TDL for Comments 151,130

Ken Bennett - Sifos Technologies
Yair Darshan - Microsemi

145A.3 PSE resistance and current unbalance

Figure 145A-3—Effective resistance verification circuit

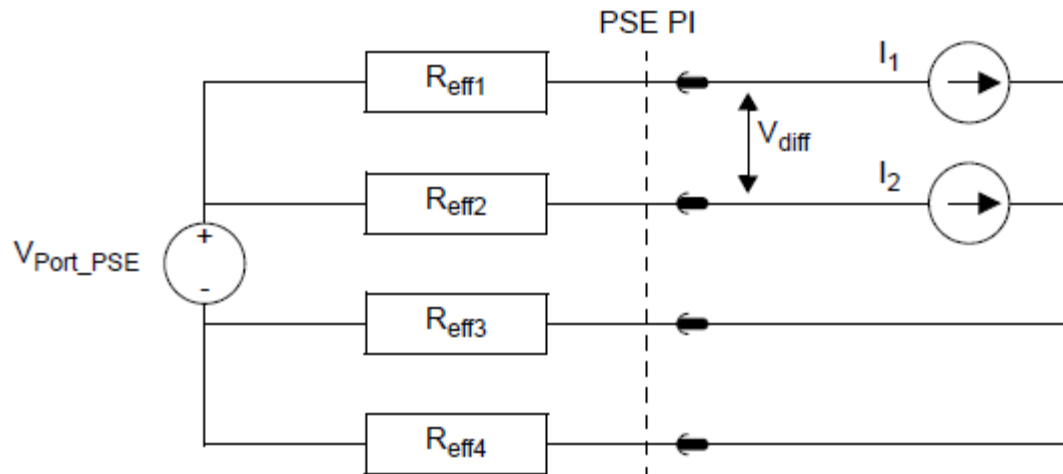
- Side 8 shows proof (by calculations) which validate the effective resistance measurement for *constant* effective resistances
- The technique can provide very close approximations of effective resistances which have negligible change
 - Current is held constant in one pair, so the effective resistance remains constant in that pair
 - In the other (measured) pair, current is near the maximum allowed, and is varied by a small relative percentage
 - thus remaining in a nearly constant effective resistance region for typical non-linear components (eg. diodes, FETs)

- Will not work if any active balancing techniques are implemented in the PSE
 - Effective resistance becomes a variable
 - A tester may not be aware of active balancing in a DUT
- Temperature variations could change effective resistance results
 - May require long waiting for steady state (test time) and recalibration of the test fixture a few times during the test for each pair
 - The above is an implementation issue, however it requires detailed guidelines, which is outside the scope of the standard

- The measurement circuit should be omitted for the following reasons:
 - As a *second, alternate* method, it is not necessary to have it in the standard
 - Set-up and measurements don't provide a significant simplification vs the other methods
 - Potential problems have been identified (see previous slide)
- Proposed Changes to the Baseline are shown in the last 3 slides of this presentation

Figure 145A-2—Effective resistance verification circuit

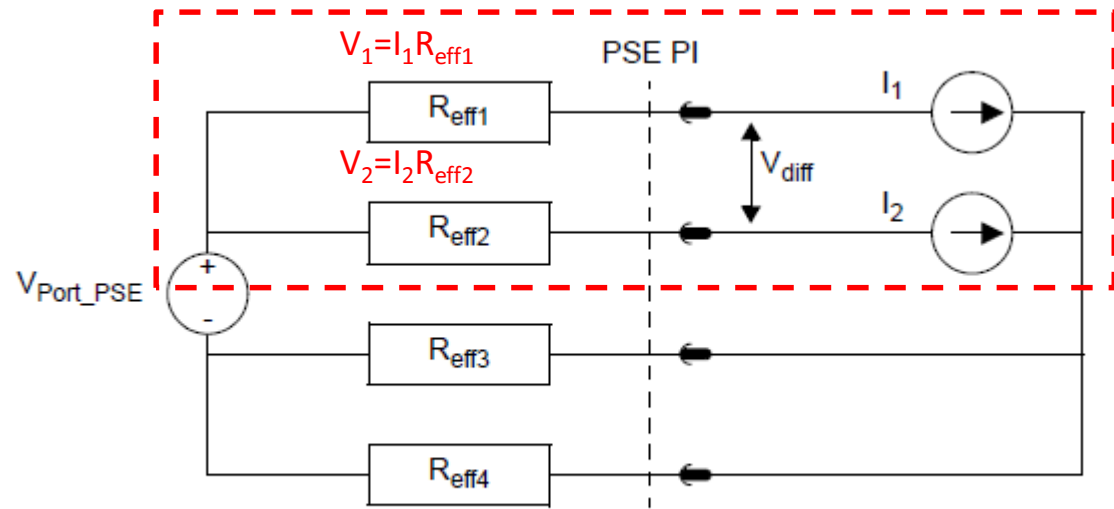
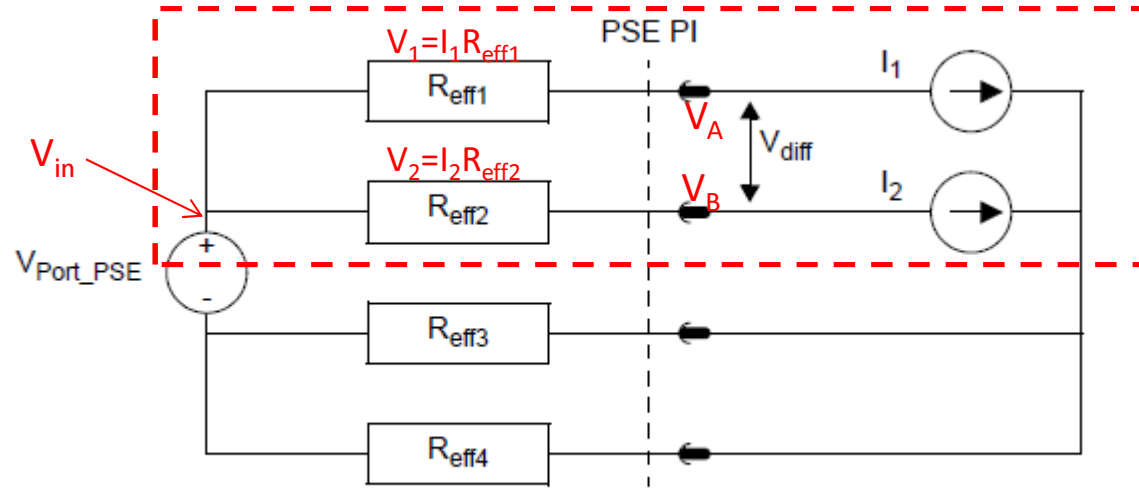
$R_{\text{eff1}} = V_1 / I_1$ I_1 is known, V_1 is not known, however:

$V_1 = V_{\text{diff}} - V_2$ and V_{diff} **can** be measured.

- 1) Holding V_2 constant (by holding I_2 constant), and
- 2) Performing a 2-step measurement to cancel V_2

$$\text{Where, } R_{\text{eff1}} = [V_{\text{diff}} - V'_{\text{diff}}] / [I_1 - I'_1]$$

- $V_{\text{diff}} = V_B - V_A = [V_{\text{in}} - V_2] - [V_{\text{in}} - V_1] = V_1 - V_2$
- $V'_{\text{diff}} = V_B - V_A = [V'_{\text{in}} - V_2] - [V'_{\text{in}} - V'_1] = V'_1 - V_2$
- $V_{\text{diff}} = I_1 R_{\text{eff1}} - V_2$
- $V'_{\text{diff}} = I'_1 R'_{\text{eff1}} - V_2$
- $V_{\text{diff}} - V'_{\text{diff}} = [I_1 R_{\text{eff1}} - V_2] - [I'_1 R'_{\text{eff1}} - V_2]$
- $R_{\text{eff1}} \approx R'_{\text{eff1}}$ ←
- $V_{\text{diff}} - V'_{\text{diff}} = I_1 R_{\text{eff1}} - I'_1 R_{\text{eff1}} = R_{\text{eff1}} [I_1 - I'_1]$
- $R_{\text{eff1}} = [V_{\text{diff1}} - V'_{\text{diff1}}] / [I_1 - I'_1]$

Resistive components will be constant. Active components have negligible change when operated within a narrow, nearly linear range

Figure 145A-3—Effective resistance verification circuit

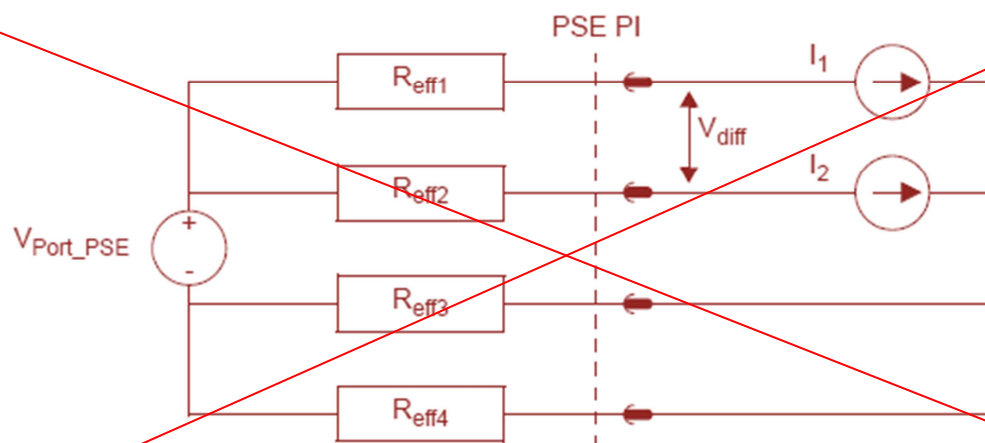
- ~~3) Reduce I_1 by 20% ($=I_1'$). Ensure I_2 remains unchanged.~~
 - ~~4) Measure V_{diff}' in the same manner as V_{diff} .~~
 - ~~5) Calculate R_{eff1} :~~
~~$$R_{eff1} = [(V_{diff}) - (V_{diff}')] / (I_1 - I_1')$$~~
 - ~~7) Repeat procedure for R_{eff2} , with I_1, I_2 values swapped.~~
 - ~~8) Repeat procedure for R_{eff3}, R_{eff4} .~~
 - ~~9) Evaluate compliance of R_{eff1} and R_{eff2} with Equation (145–15). Evaluate compliance of R_{eff3} , and R_{eff4} with Equation (145–15).~~
- ~~The effective resistance verification method applies to the general case. If pair-to-pair balance is actively controlled in a manner that changes effective resistance to achieve balance, then the current unbalance measurement method described in 145.2.8.5.1 may be used.~~

There ~~are two~~ is an alternate verification methods for $RPSE_{max}$ and $RPSE_{min}$ and determining conformance to Equation (145-15) and to $ICon-2P-unb$.

A ~~Mm~~ measurement methods to determine $RPSE_{max}$ and $RPSE_{min}$ and $ICon-2P-unb$ ~~are is~~ defined in 145A.3.1 and 145A.3.2.

If pair-to-pair balance is actively controlled in a manner that changes effective resistance to achieve balance, then the current unbalance measurement method described in 145.2.8.5.1 should be used.
